#### TOWN OF MILFORD, NH OFFICE OF COMMUNITY DEVELOPMENT

#### **STAFF MEMO**

Subject: KGL Landscape Construction, LLC, Tax Map 8, Lot 73, 211 Mont Vernon Road. Public hearing for a Minor Subdivision application to subdivide the existing lot of record into three total parcels within the Residential A Zoning District.

RE: Tax Map Parcel 8-73, 211 Mont Vernon Road Minor Subdivision KGL Landscape Construction, LLC (Review Response Letter)

Aerial Photograph of the Subject Property:

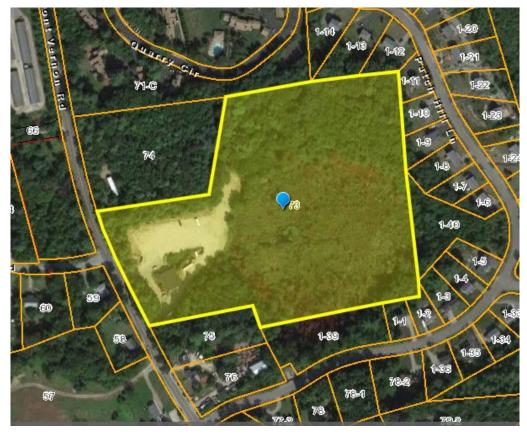
**Environmental Programs/Stormwater**: No drainage plan has been incorporated/submitted to address the management of the stormwater and drainage from the commercial operations. Please clarify if the existing drainage area and pipes shown in the aerial and plan below are being removed. Please explain how the stormwater and drainage from the commercial property are being managed.

The detention basin and outflow structure will remain as is and will not be disturbed. The proposed driveway for Proposed Lot 8-73-2 will run along the proposed access easement that crosses Proposed Lot 8-73 and will avoid the existing drainage area of concern.

V FILE: 10605B04A.dwg PROJ. NO. 1060.04 SHEET: EX-1 PAGE NO. 2 OF 2

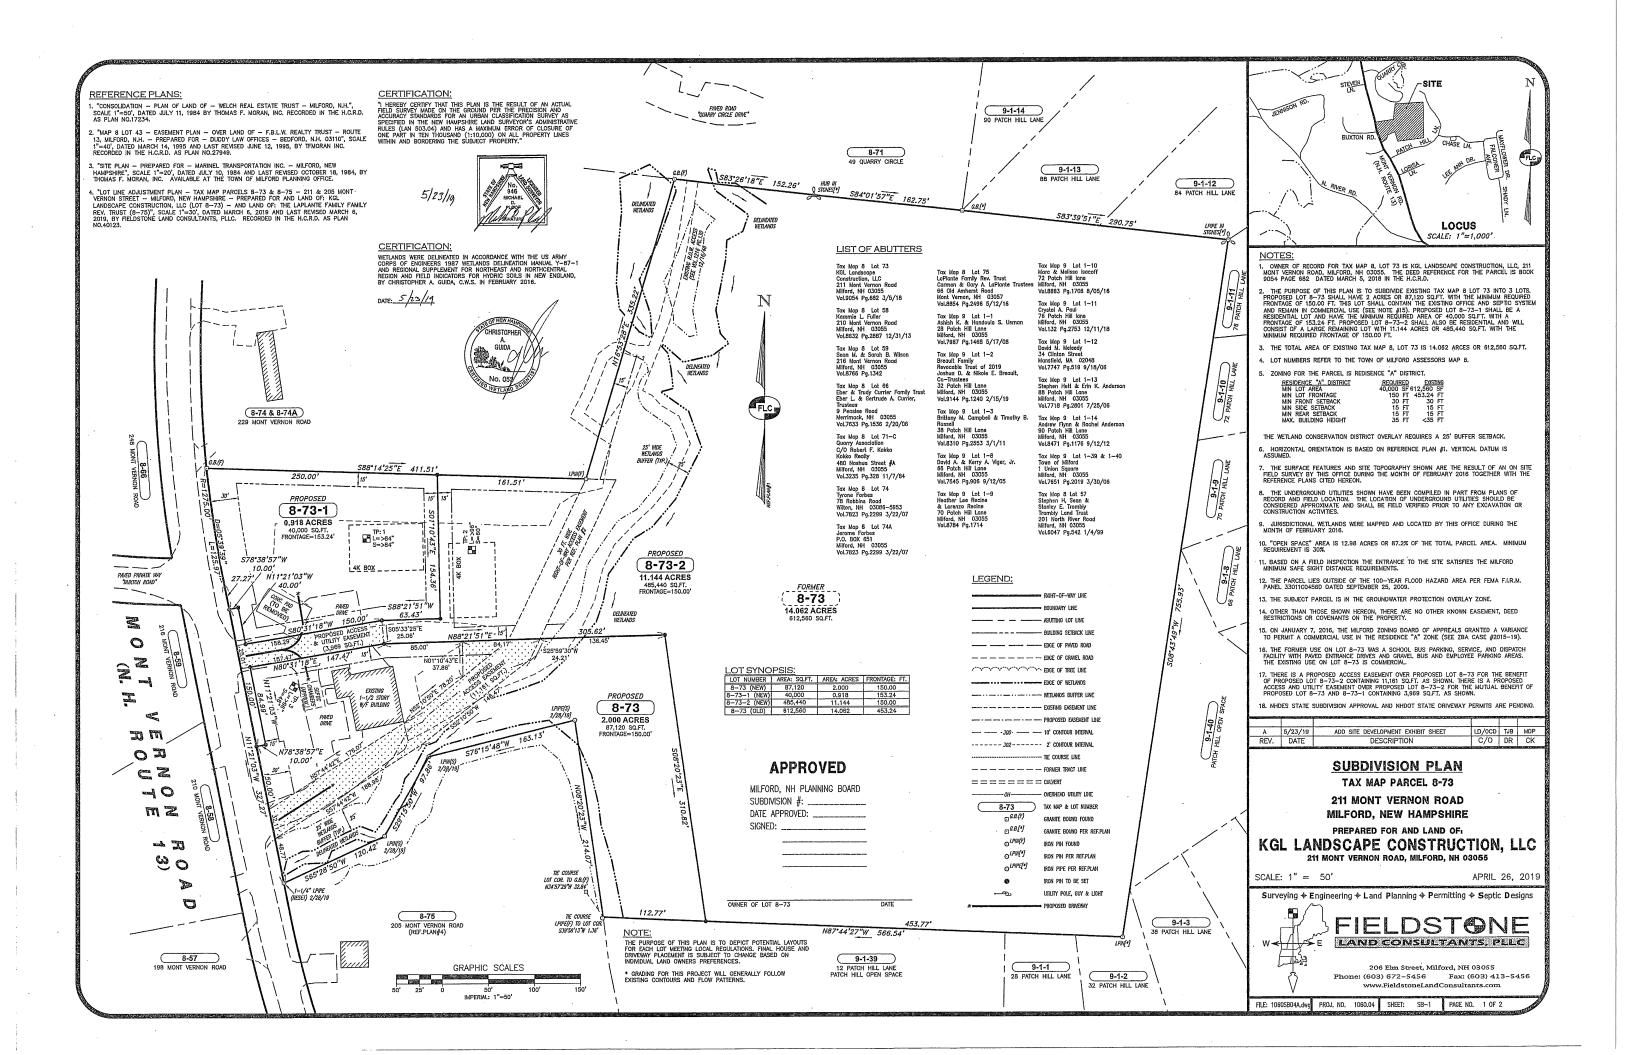
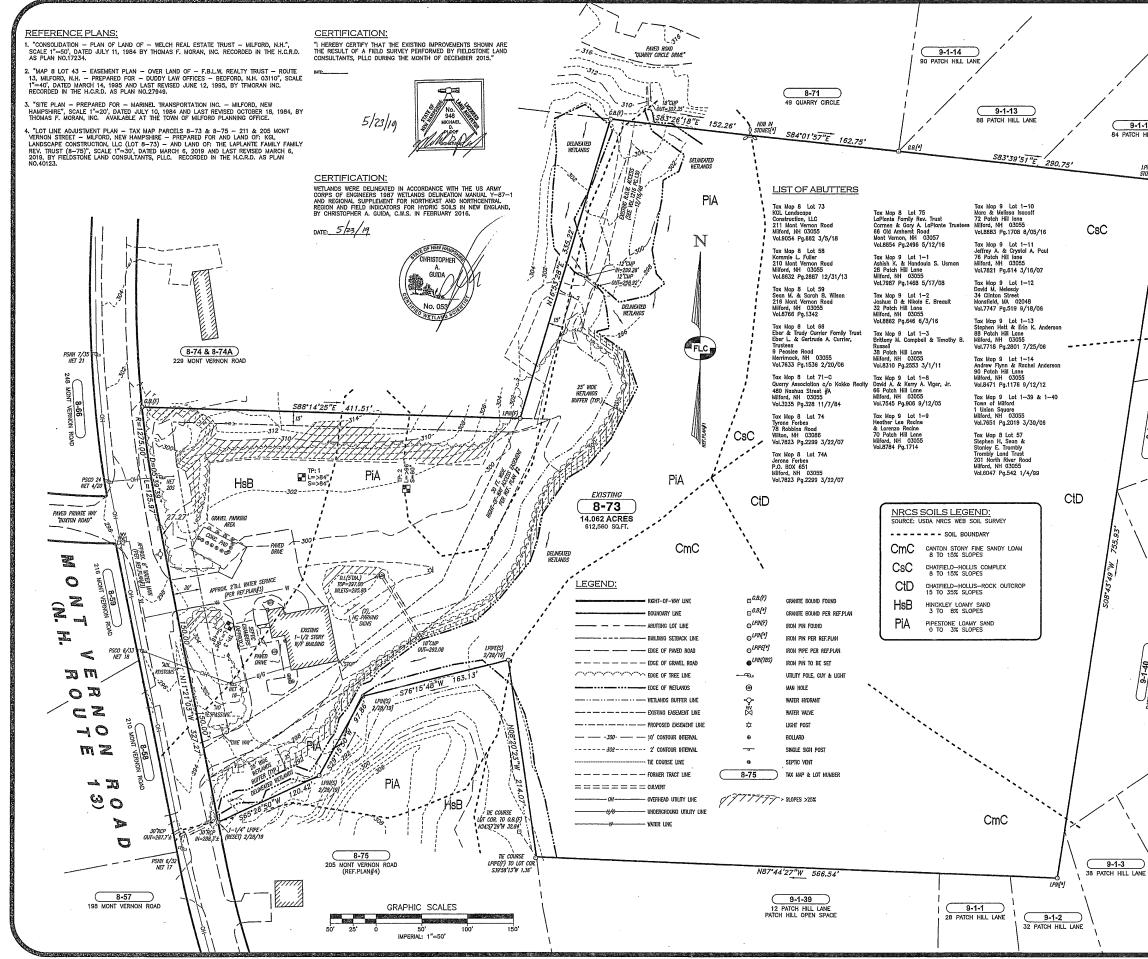
- 7. Subdivision Plan, Sheet 2. Please explain if the unpermitted berm/grading along the frontage of the property will be returned to its pre-disturbed state or incorporated in the layout and design of the proposed subdivided lot. *Addressed*

- 8. Subdivision Plan, Sheet 1, Sheets 1 and 2. Please clarify if the existing drainage area and pipes shown in the aerial and plan below are being removed. If yes, please explain how the stormwater and drainage from the commercial property are being managed. extent and location of the wetland resource areas, please include the conceptual final grading plan for the properties. *Partially Addressed.* The existing drainage structure serving the commercial use on Lot 8=73 is now located on an adjacent property and will require the creation of a drainage and maintenance easement for the benefit of the parent lot.

The berm along the frontage portion of the property was placed to create a buffer from sight and sound between the site and New Hampshire Route 13. The new owners of the property do not wish to construct the approved site plan for the selfstorage operation and would prefer to keep the berm in the current location being that the new application before the Board is for two residential lots.
